UPPER MORELAND TOWNSHIP
Community Development Committee Meeting
February 14, 2022 at 7:00 p.m.

- A. Application of Land Development by Federal Realty Investment Trust at the Willow Grove Shopping Center (Park Avenue) for proposed 18K square foot building and associated site improvements. (attachment).
- B. Request for waiver of Land Development by Palz Tap House, 1902 County Line Road, for construction of a deck with roof for outdoor dining (attachment).

Pursuant to your request, Gilmore & Associates, Inc. has reviewed the submitted land development plans for the above-referenced project and offers the following comments for consideration by Upper Moreland Township:

RE: **Traffic Review #1 – Preliminary/Final Land Development Plans**
Willow Grove Shopping Center Modifications – Retail Pad Site
Upper Moreland Township, Montgomery County, PA
McMahon Project No. 821A16.11

C. Parking Area Landscaping (Section 300-43, D.)

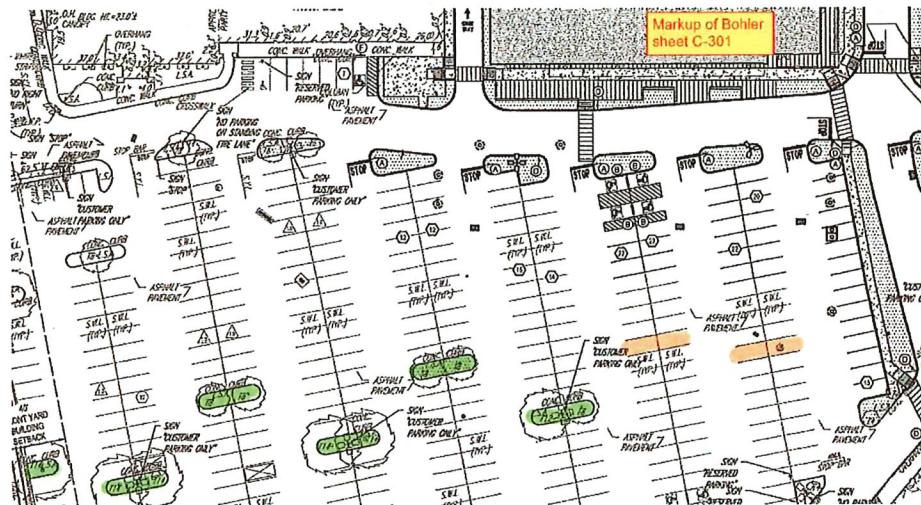
1. A minimum of 10% of any parking facility over 5,000 square feet in gross area, outside curb to outside curb, shall be devoted to landscaping. (Section 300-43 D. (1) (b)) A note indicates

2. Planter islands are to be crowned to a height of eight (8) inches above the average top of curb height. (Section 300-43 D. (1) (c)) This information should be added to the plan in the form of a detail included on both the landscape drawings and civil drawings.
3. A maximum of twenty (20) parking spaces in a row is permitted without a landscape island for the Shopping Center use. (Section 300-43 D. (2) (a)) We note that with the proposed site plan layout, the number of non-conforming parking rows with more than twenty spaces without an island remains the same as existing conditions. That said, we recommend that islands are added in the parking rows as marked in orange below, to continue the existing parking island layout. This would decrease the deficiency with parking area greenspace.
